## Addendum #01 - ADDENDUM 01

### ATTHS-Silsbee CO Chiller Replacement-Reno Project #171936

## **ADDENDUM #1 (02/01/2019)**

SHEET TITLE: ELECTRICAL SCHEDULES, SYMBOLS, ABBREVIATIONS, AND GENERAL NOTES

AT&T PROJECT NUMBER	DATE: 1/11/2019	SCALE: NOTED
T22427	DRAWN BY: S.D	CHECKED BY: M.D
AT&T AUTHORIZATION	SHEETS: - OF: - SHEETS	SHEET NO:
PARISA MAZRATIAN	AT&T DRAWING NO:	E1.01

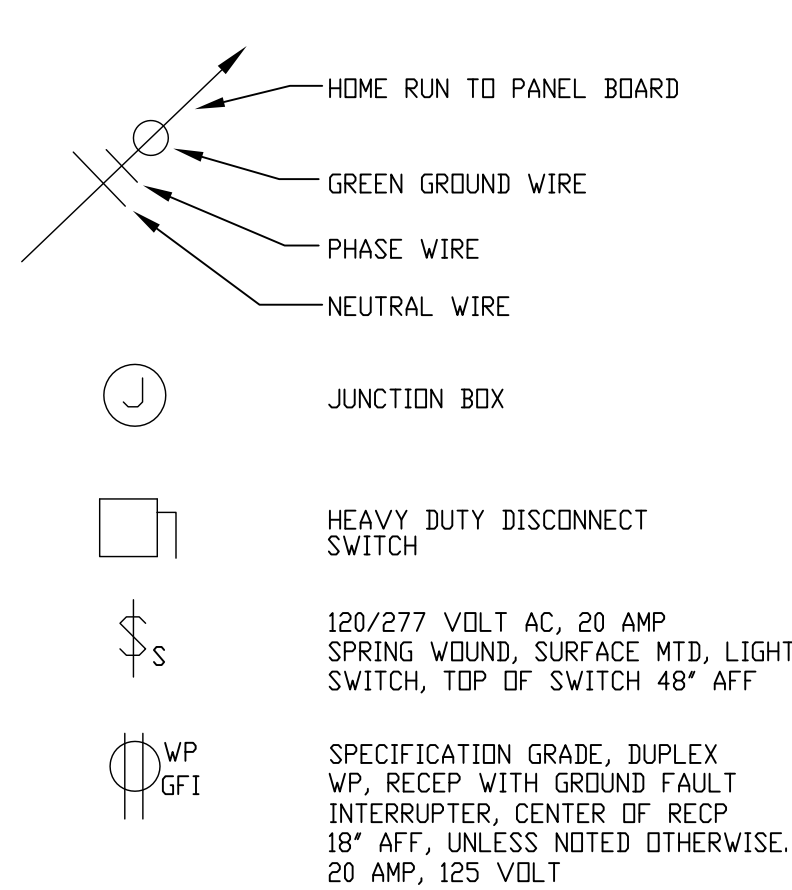
5. DWG. E1.02: Plan Keyed note-21: shall be revised. The existing chilled water pump motor starters shall be removed and replaced with new VFDs as specified in revised DWG. E1.01.

VARIABLE FREQUENCY DRIVE (VFD) SCHEDULE						
MARK	SERVICE EQUIPMENT	ELECTRICAL				REMARKS
		VOLT	PH	HZ	HP	
(N) VFD-1	(N) CHP-1	208	3	60	7.5	ABB SERIES ACH-550 WITH NEMA-1 TYPE ENCLOSURE
(N) VFD-2	(N) CHP-2	208	3	60	7.5	ABB SERIES ACH-550 WITH NEMA-1 TYPE ENCLOSURE

- (N) VARIABLE FREQUENCY DRIVE (VFD) VFD SHALL BE FACTORY FURNISHED, INSTALLED, WIRED, TESTED WITH
  - 2 MECHANICALLY INTERLOCKED, IEC RATED, SIZED FOR THE SPECIFIED FULLY LOADED MOTOR HP CONTACTORS. THE CONTACTORS SHALL BE RATED TO OPERATE CONTINUOUSLY, 24 HOURS A DAY, 7 DAYS A WEEK, 365 DAYS A YEAR.

- 3% PERCENT INPUT LINE REACTOR.
  - A MAIN FUSIBLE DISCONNECT SWITCH AND A PROPERLY SIZED INVERTOR INPUT ISOLATION DISCONNECT SWITCH OR CKT BRKR TO CONTROL AC POWER TO VFD COMPONENTS (DURING REPAIR AND TESTING) WHILE THE MOTOR IS RUNNING IN THE BYPASS MODE.

- SHALL HAVE FACTORY INSTALLED NEMA-1 ENCLOSURE.
  - 4 POSITION FACTORY FURNISHED, INSTALLED, WIRED, AND TESTED MANUAL DRIVE-OFF-TEST-BYPASS SWITCH.
  - JOB SITE START UP SERVICES, INCLUDING PROGRAMMING OF VFDs SHALL BE PROVIDED AND ALL COSTS SHALL BE INCLUDED IN THE BID. EACH VFD SHALL BE FULLY FACTORY WARRANTED FOR A PERIOD OF 1 YEAR.

- SHALL BE UL LISTED AND COMPLY WITH ALL REQUIREMENTS OF UL 508 AND LATEST NEC.
  - THIS VFDs SHALL CONTROL SPEED OF (N) CHPs TO PROVIDE CHILLED WATER FLOWS AND SCHEDULED PRESSURE.
